Sundry Print Report

Well Name: ARKENSTONE 31 Well Location: T23S / R31E / SEC 31 / County or Parish/State: EDDY /

Notice of Intent

Type of Action: APD Change

| | WELL LOCATION AND | ACREAGE DEDICATION PLAT | | | | | |

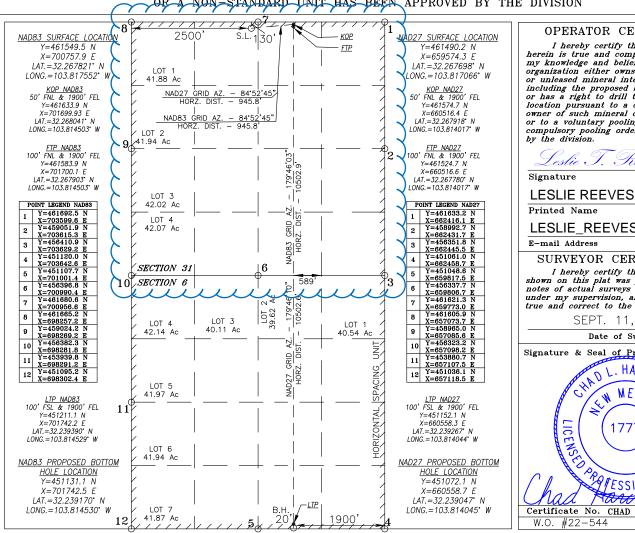
Procedure Description: OXY USA Inc. respectfully requests approval to amend the subject well AAPD BHL, change the pool to two noted wofcamp pools, amend the HSU, and update the drilling plans (casing, cementing, mud programs). The updated well plats, drill plan and directional plan are attached. The surface hole is not changing. Old BHL: 20' FSL 2100' FEL O-31-23S-31E New BHL:20' FWL 1900' FEL 0-6-24S-31E

| UL or lot No. | Section | Township | p | Range | Lot Idn | Feet from the | North/South line | Feet from the | East/West line | County |
|----------------|-----------|----------|------|--------------|---------|---------------|------------------|---------------|----------------|--------|
| 0 | 6 | 24-9 | S | 31-E | | 20 | SOUTH | 1900 | EAST | EDDY |
